# ***Interactive comment on “The Influence of a Prolonged Meteorological Drought on the Catchment Water Storage Capacity: A Hydrological Model Perspective” by Zhengke Pan et al.***

**Zhengke Pan et al.**

Responses to Referee #1: This paper represents an interesting huge work, the main objective of this paper is to detect the possible changes in catchment water storage capacity induced by a prolonged meteorological drought. It will also help improve our ability to simulate the hydrological system. Meanwhile, the structure is clear and analyses and conclusions in this paper are reasonable and logical. Overall, it is a nice paper with proper methodology and complete discussion on the main findings. A minor modification should be considered before publication.

**Fig. 1.** Figure 1. Location map of the study catchments in southeastern Australia.

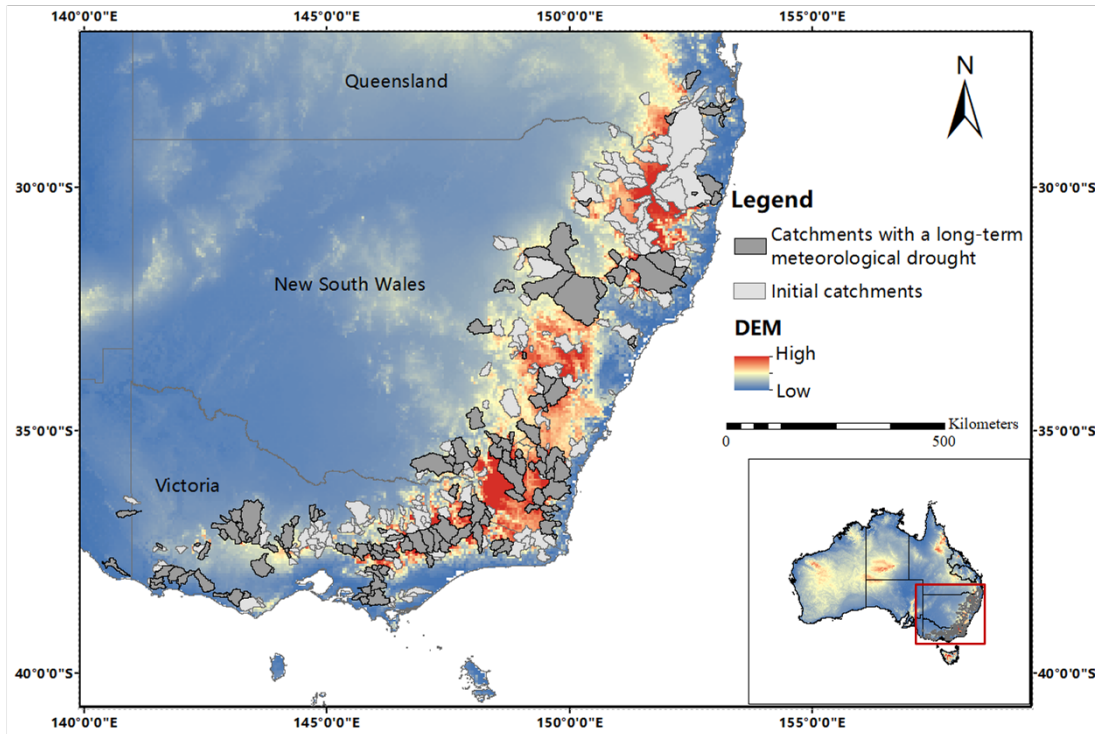
A9: It's better to add latitude and longitude to the location map of the study catchments (Figure 1). Reply: Thanks. Changes will be made in the revised Figure 1.

**Fig. 2.** Figure 4. Location map of the catchments with the significant and non-significant shifts in the CWSC.

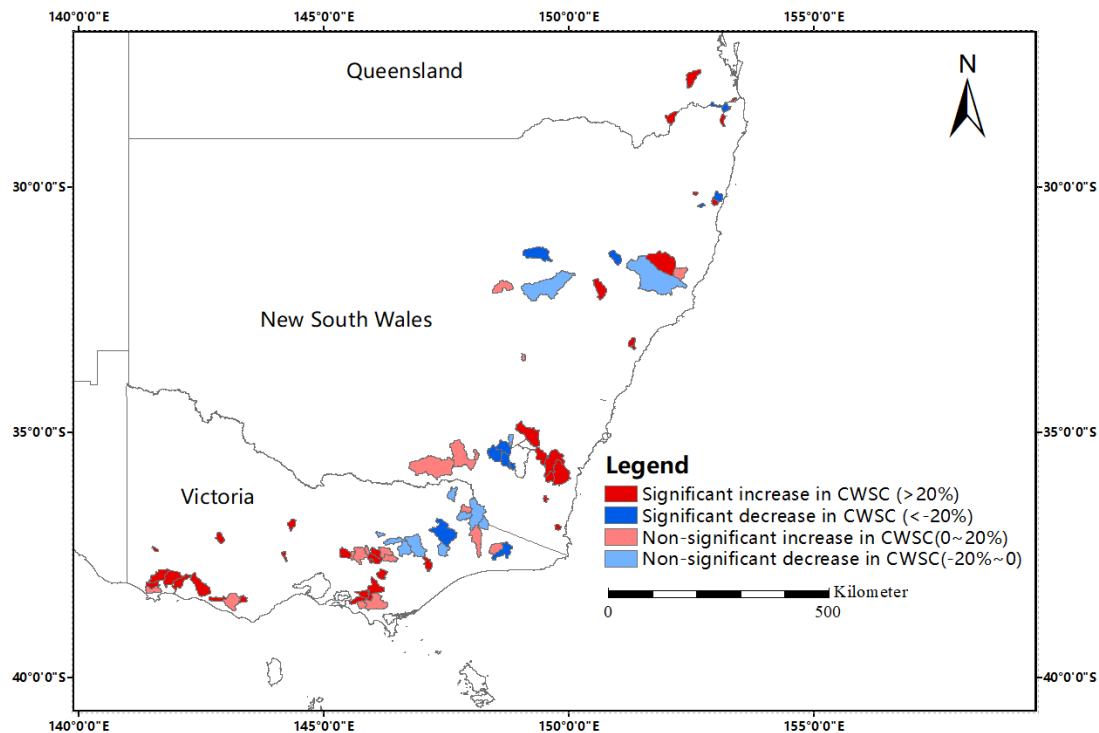
A11: Figure 4 can be improved. The figure should show the change directions and magnitudes of the CWSC at the same time. It is better for readers to understand the shifts of the CWSC in the adjacent catchments. Reply: Thanks. Changes will be made as suggested in The modified Figure 4 in Figure 2 in the supplement.
